Relevant Information for Local Planning Panel

SUBJECT: Information Relevant To Item 3 – Development Application: 21C Billyard Avenue, Elizabeth Bay – D/2023/727

**SUPPLEMENTARY JOINT EXPERT REPORT ADDRESSING HEIGHT OF BUILDINGS
CALCULATION**

Supplementary Joint Expert Report
Appendix B: Height Plane Amendment

Bettar Height Plane - Amended Plan

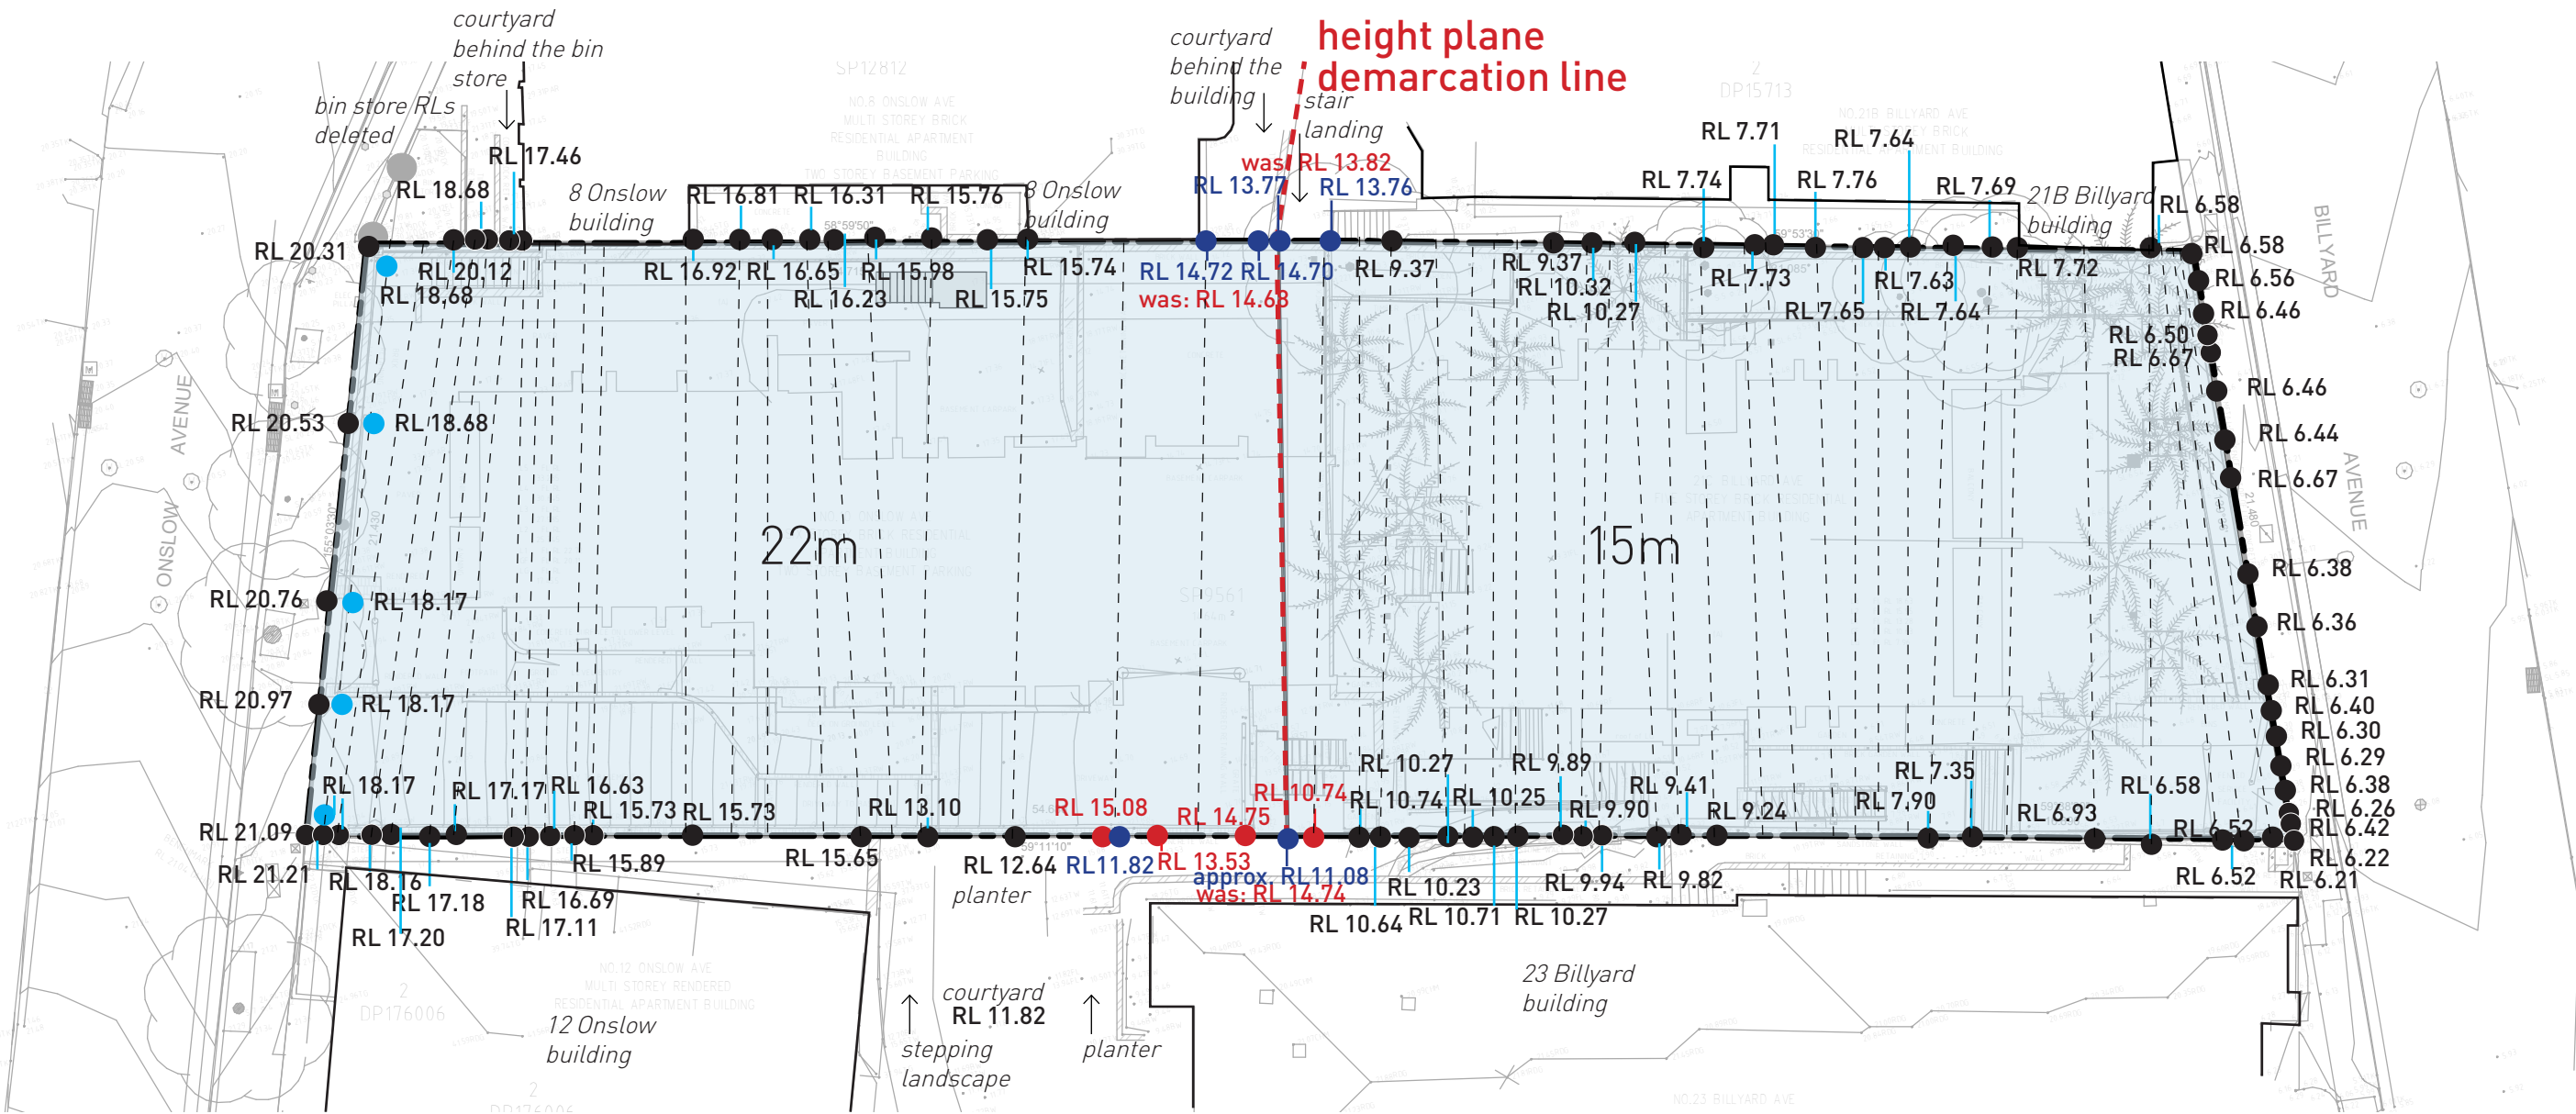
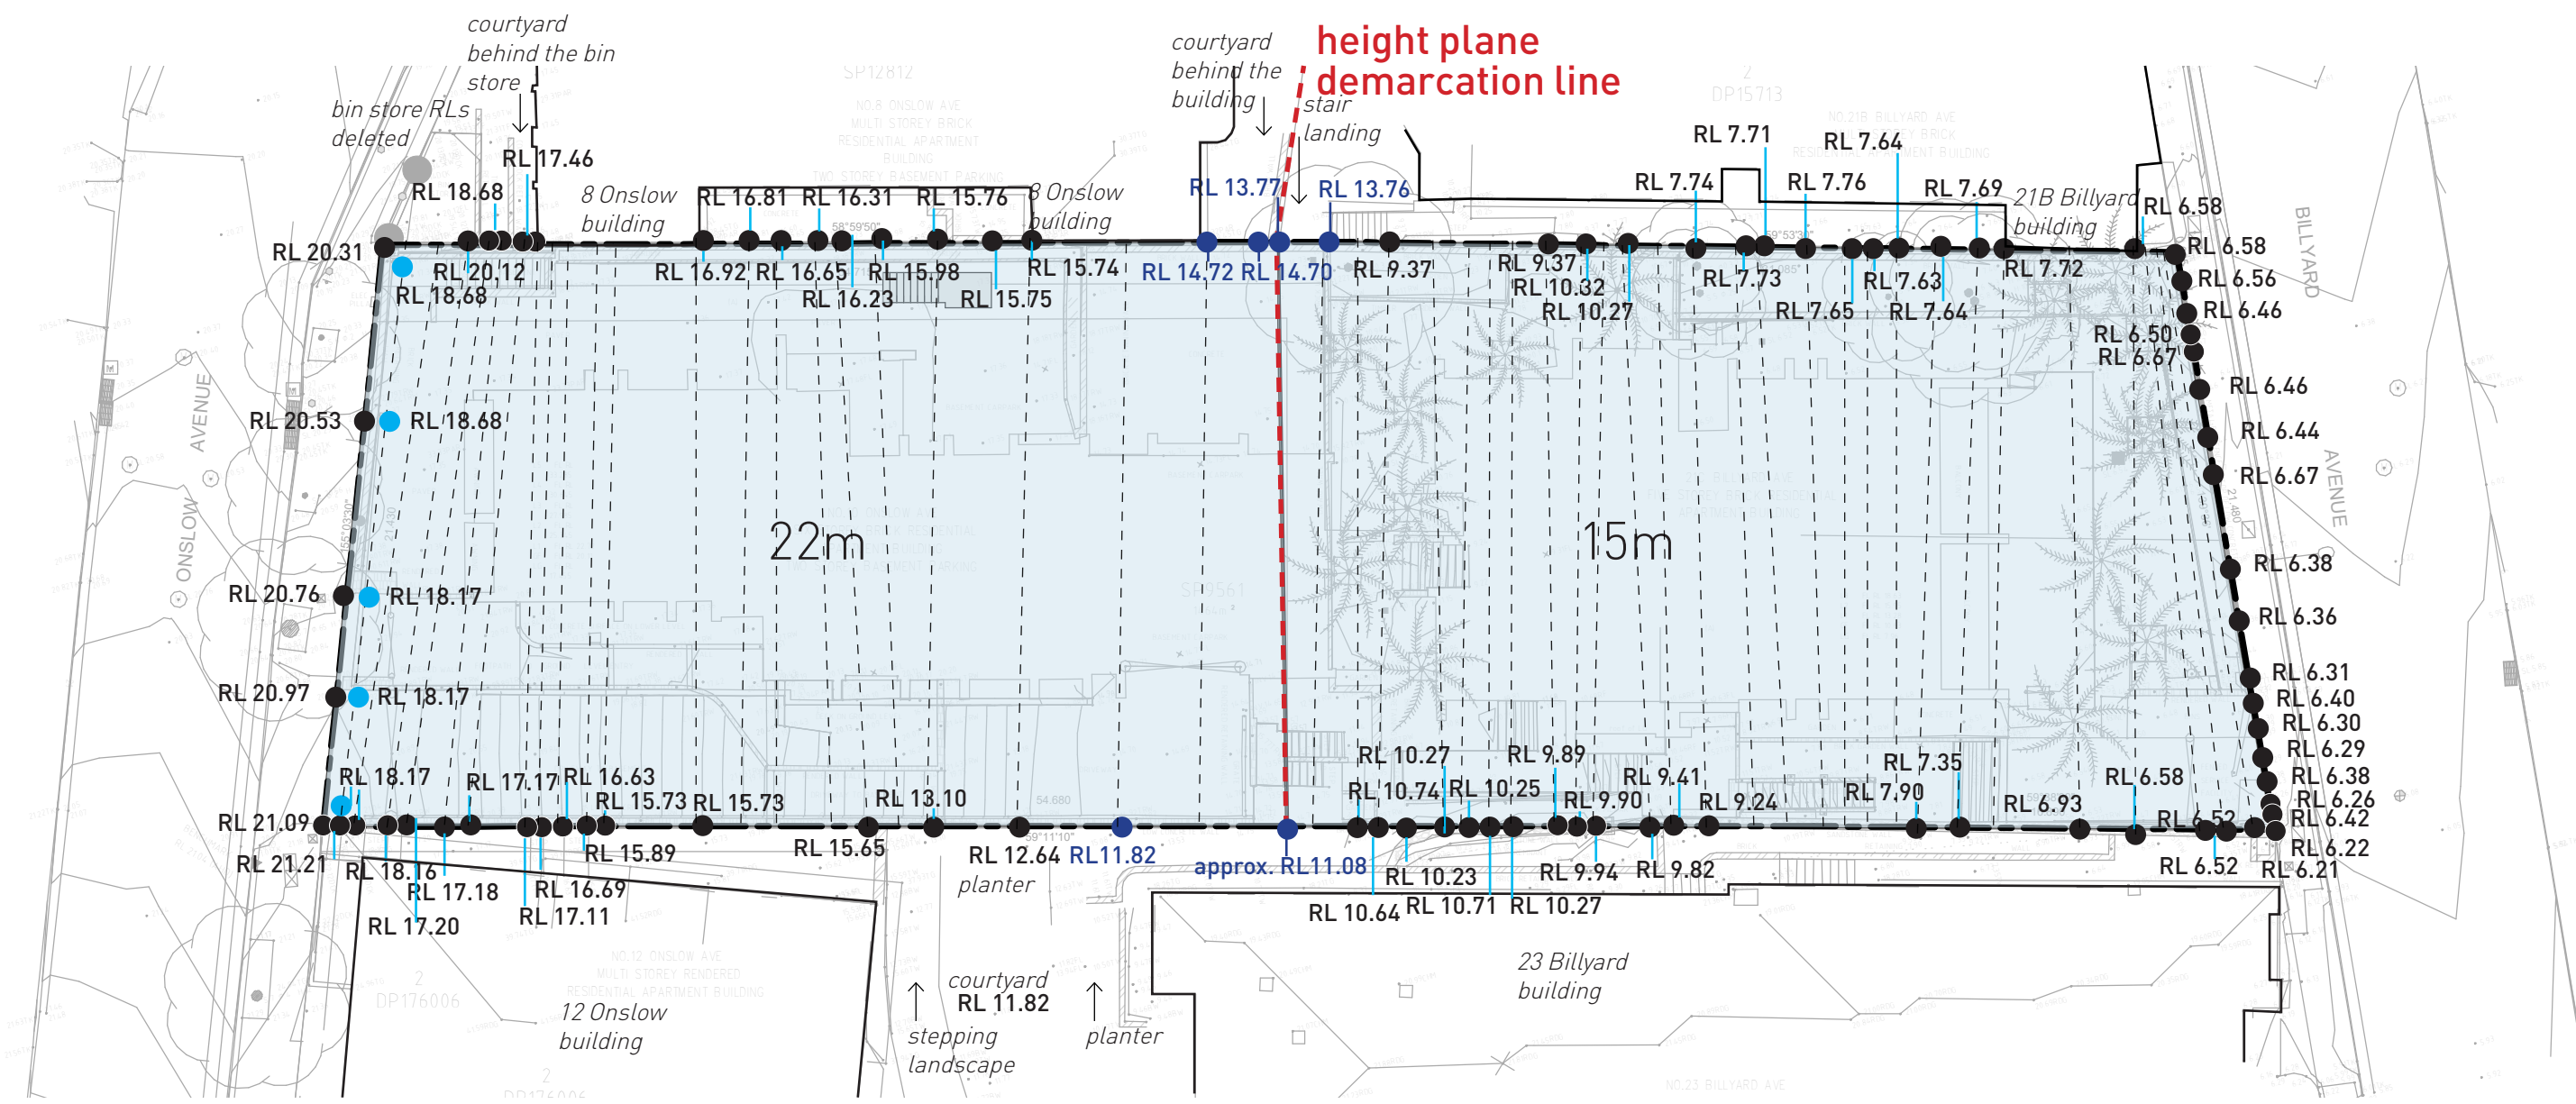
- Removed Points
- Amended Points

● Amended Points
